PROJECT: **SECOND FLOOR FIT-OUT (INTERIOR RENOVATION)**
FOR DAUPHIN ISLAND SEA LAB
GMC PROJECT NO. AMOB260001

ADDENDUM NUMBER 3 **August 26, 2026**

PROJECT: SECOND FLOOR FIT-OUT (INTERIOR RENOVATION)
FOR DAUPHIN ISLAND SEA LAB
GMC PROJECT NO. AMOB260001
DCM PROJECT NO. 2026138

A3 WINDOW SILL DETAIL
SCALE: 3" = 1'-0"

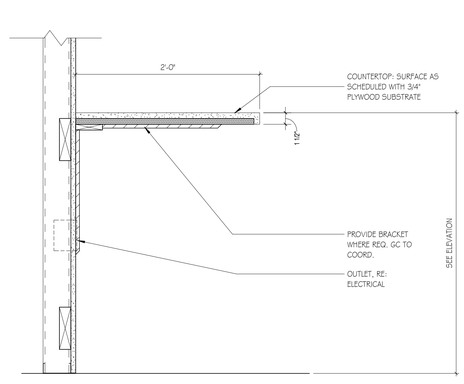
13. Please provide the required window sill detail, including dimensions, depth, and any other applicable installation requirements for the solid surface (SS-2) window sills.
    a. Millwork General note states "ALL WINDOWS TO HAVE SOLID SURFACE (SS-2) SILL U.N.O." There is no detail or dimension indicating sill details or depths. Please advise.
    b. Under the Millwork General Notes it states that: **"ALL WINDOWS TO HAVE SOLID SURFACE (SS-2) SILL U.N.O."** However, we have been unable to locate any details or dimensions indicating the required sill configuration or depth.

RESPONSE: Provide and install 52" wide x 5-1/2" deep solid surfaces sills for all second floor windows with 1-1/2" turn down. Revised Sheet A7.12R Millwork Details (Addendum No. 3) dated 8/26/2026 is attached with a new window sill section detail and window sill plan detail with dimensions.

ROOF FRAMING PLAN

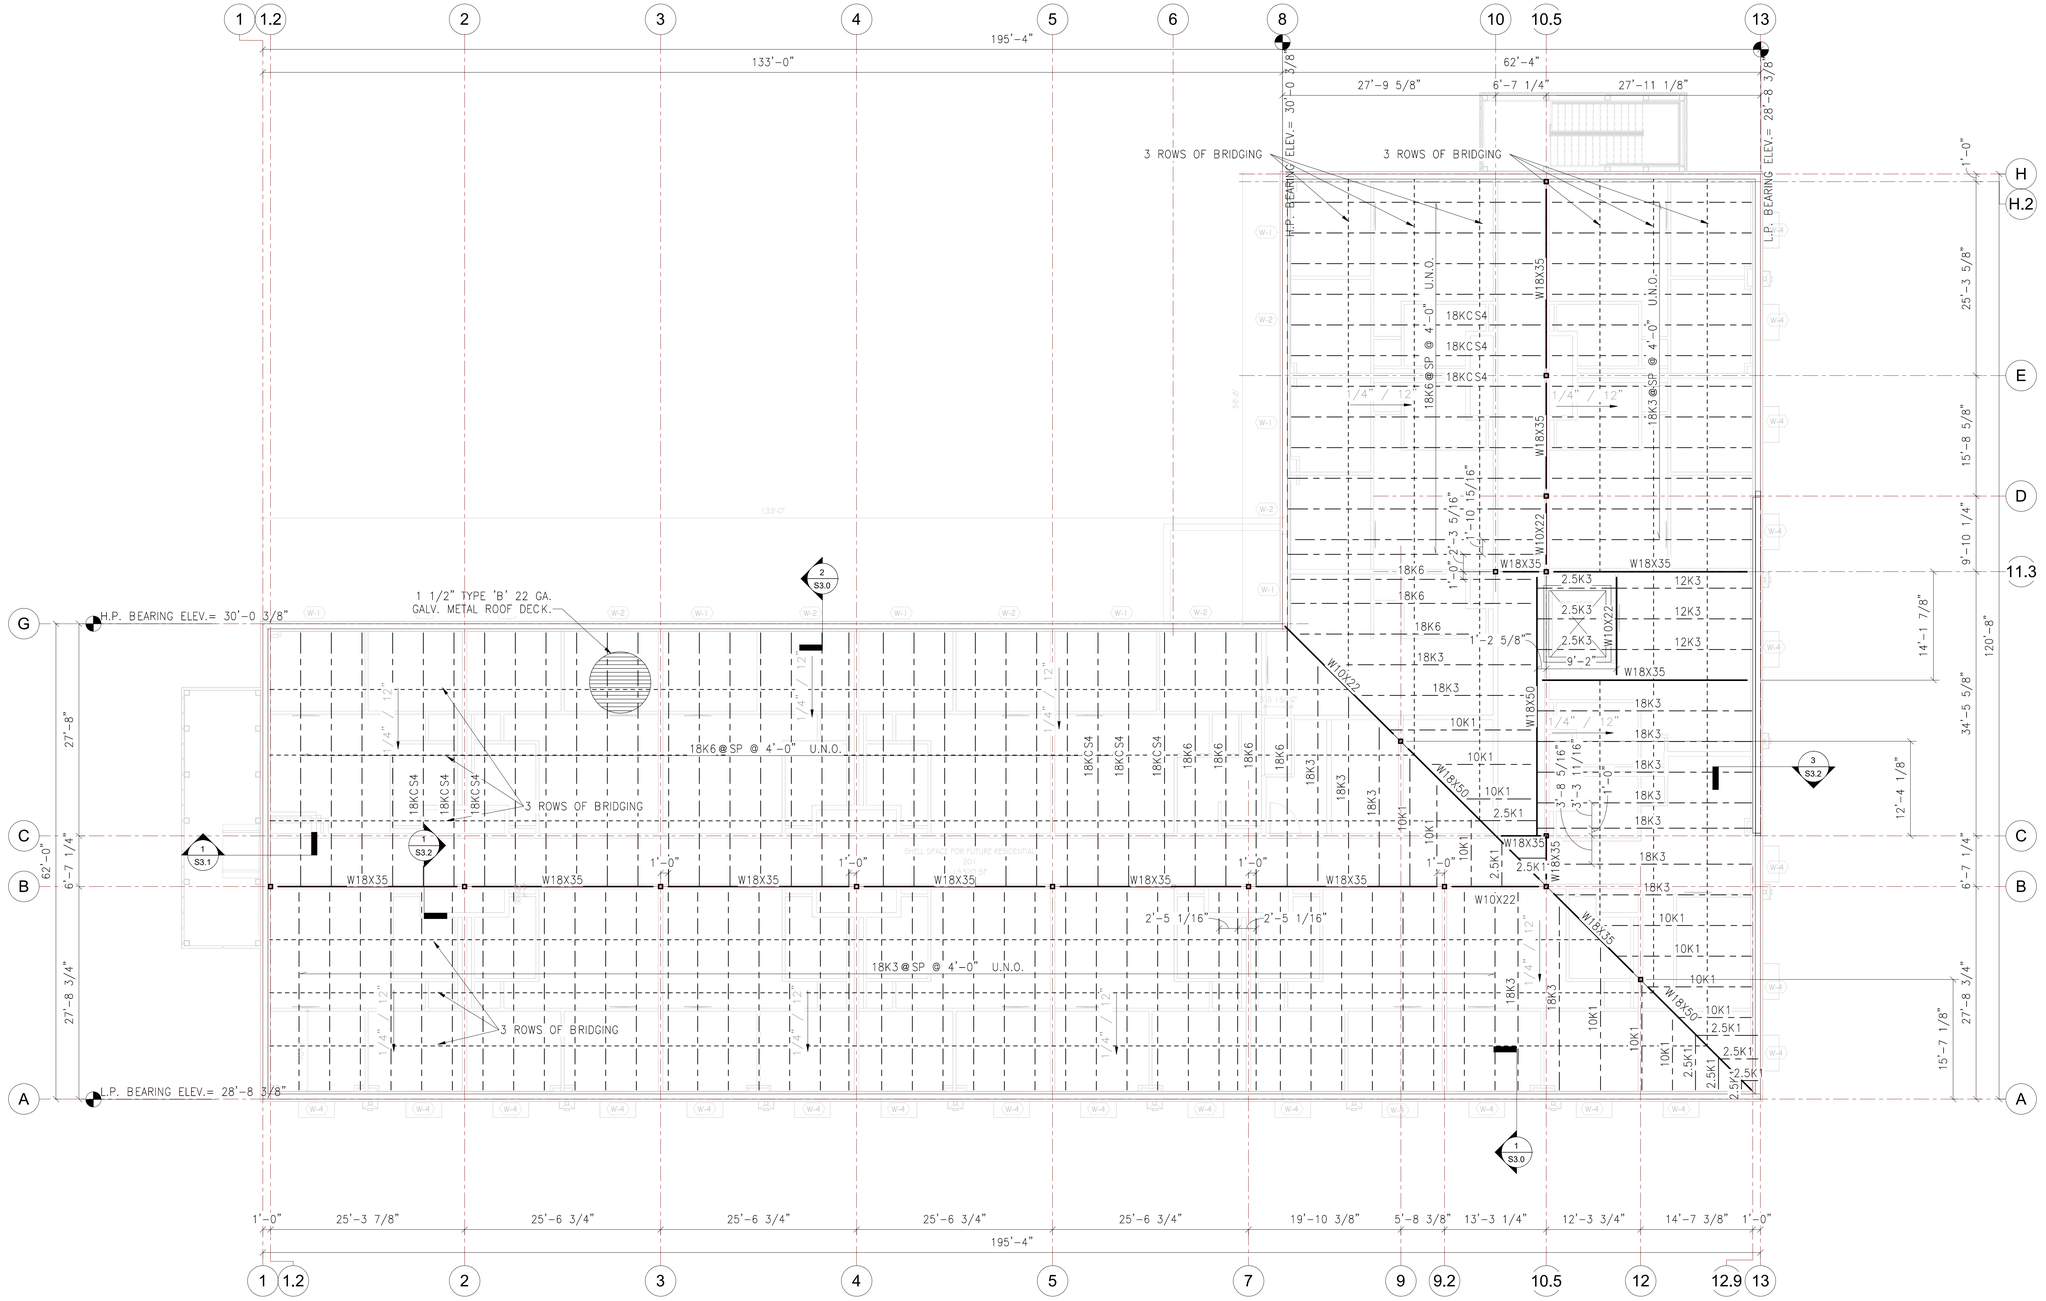
16. Please provide the 2nd floor framing plan structural drawings for use in figuring details H1, H3, H5, and H7 on G2.02.

RESPONSE: Phase 1 Structural Sheet S2.23 Roof Framing Plan is attached FOR REFERENCE ONLY FOR Fire Related Wall Partition Details. Contractor shall account for as built variations and field verify existing conditions.
